SUBJECT: Consideration of tentative approval of Sakura East JZ23-41 with Zoning Map Amendment 18.743, to rezone from Light Industrial to Town Center One with a Planned Rezoning Overlay (PRO).

SUBMITTING DEPARTMENT: Community Development, Planning

FORMAL PRO CONCEPT PLAN
July 30, 2024

ORIGINAL ISSUE DATE:
 MAY 13, 2024
 DRAWING TITLE
PRELIMINARY SITE PLAN

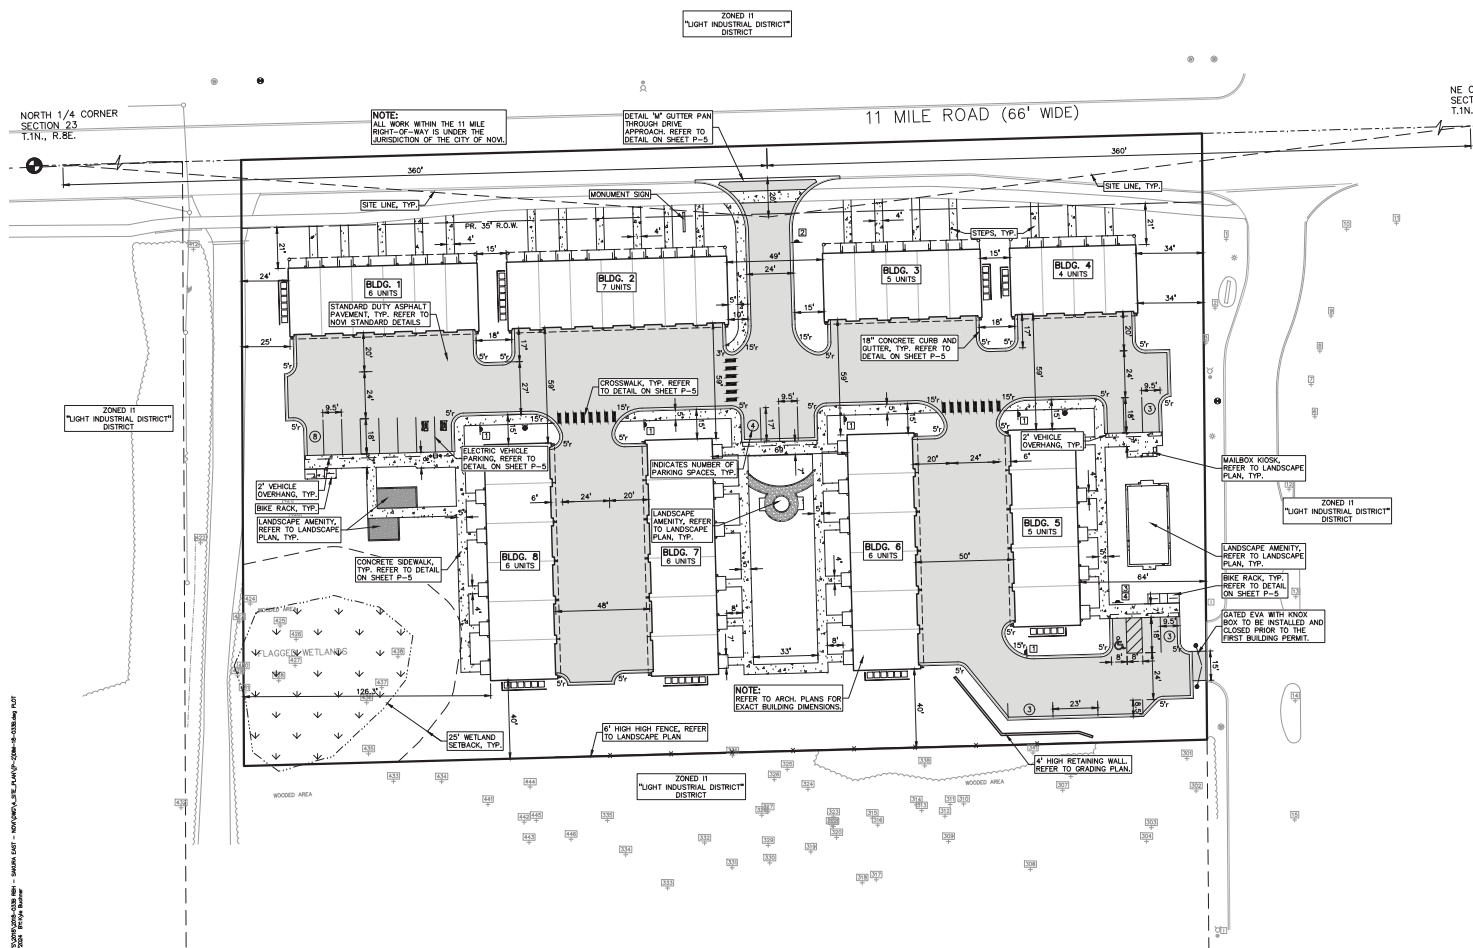
- a. An in-depth explanation of the need for a Wetland and Watercourse Setback can be found on page 3-67 of the [City of Novi Zoning Ordinance](#).
 - b. No impacts are proposed to the on-site Wetland. However, impacts appear to be proposed to the 25-foot Wetland Setback. Sheet P-2 shows a small portion of concrete sidewalk will be

placed within the 25-foot Wetland Setback. Additionally, Sheet P-3 shows proposed contours (between 903-906 feet above mean sea level) will occur within the 25-foot Wetland Setback.
